URBAN UNION

**Master Use
Permit Revision**

Project #3020902

URBAN UNION: 501 FAIRVIEW AVENUE NORTH, SEATTLE, WA 98109

ORIGINAL SIGNAGE LOCATIONS

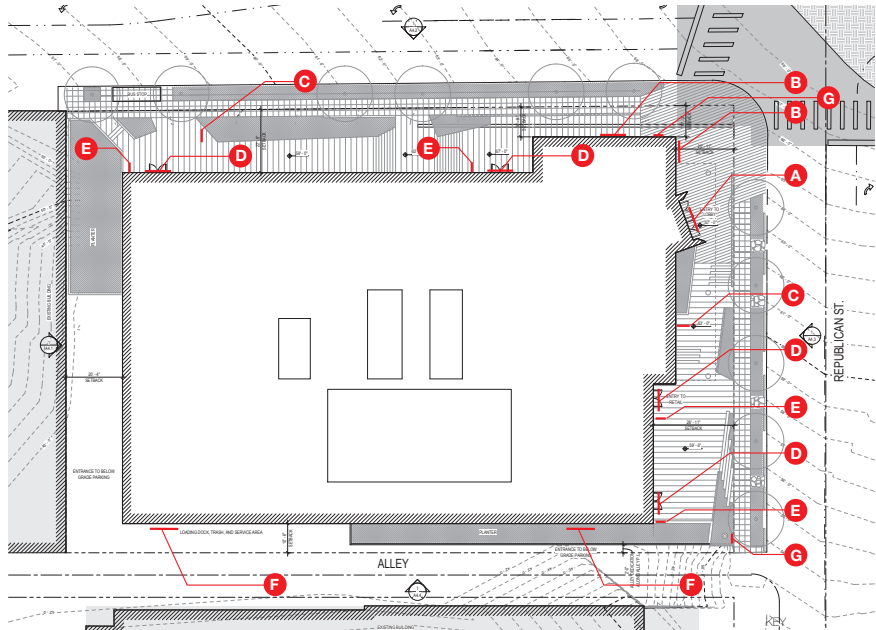
- e. Signage opportunities should be provided on the façade, especially near the southwest corner (to avoid the need for sandwich boards in the sidewalk). (D-9)

RESPONSE: See the identified opportunities for building mounted and free standing signage for building identification, tenant signage, and parking garage entries. Signage will be oriented for both pedestrian and vehicular orientation as viewed from Republican Street and Fairview Avenue as well as the alley.

Proposed Signage Locations

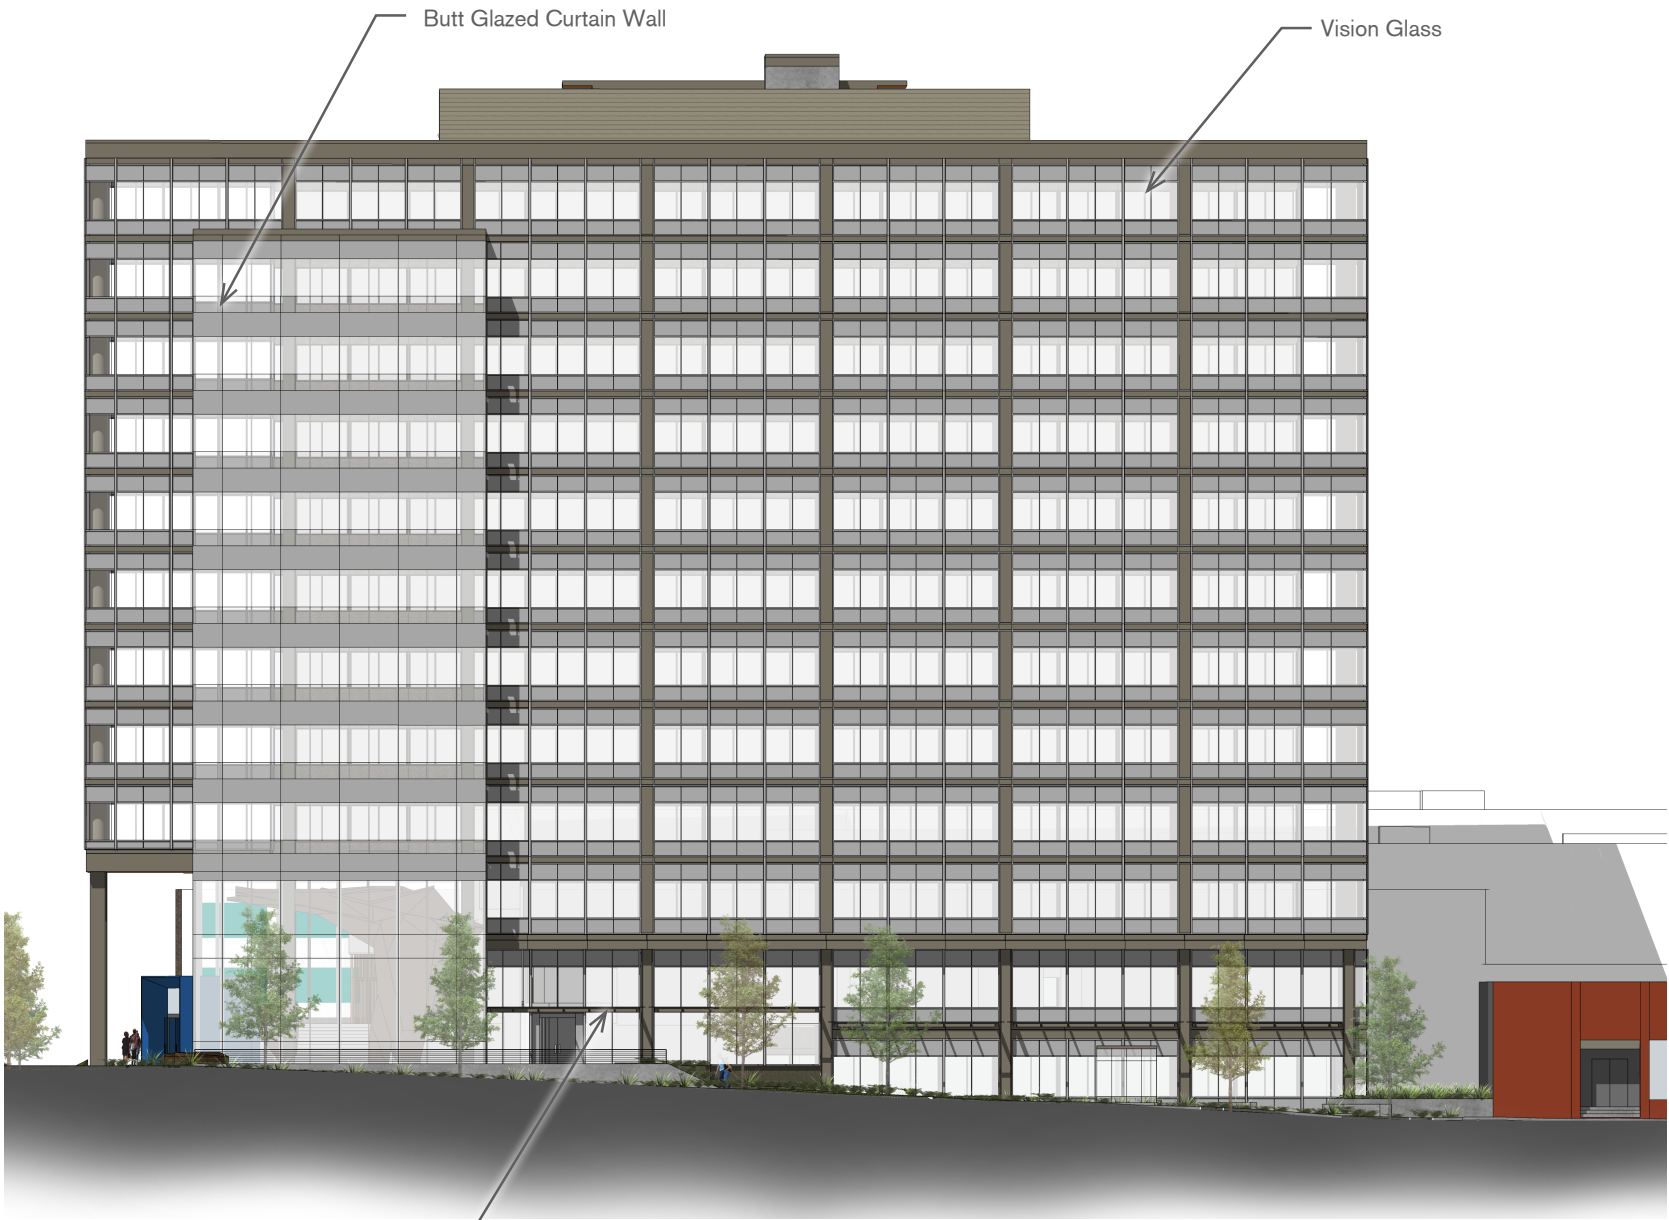
The signage bands identified on the South, East, and North elevations (in red) are consistent and in compliance with the city’s sign regulations, Seattle Municipal Code “SMC” 23.55.030.

Signage will be integrated from the base of the building to the parapet of each facade.
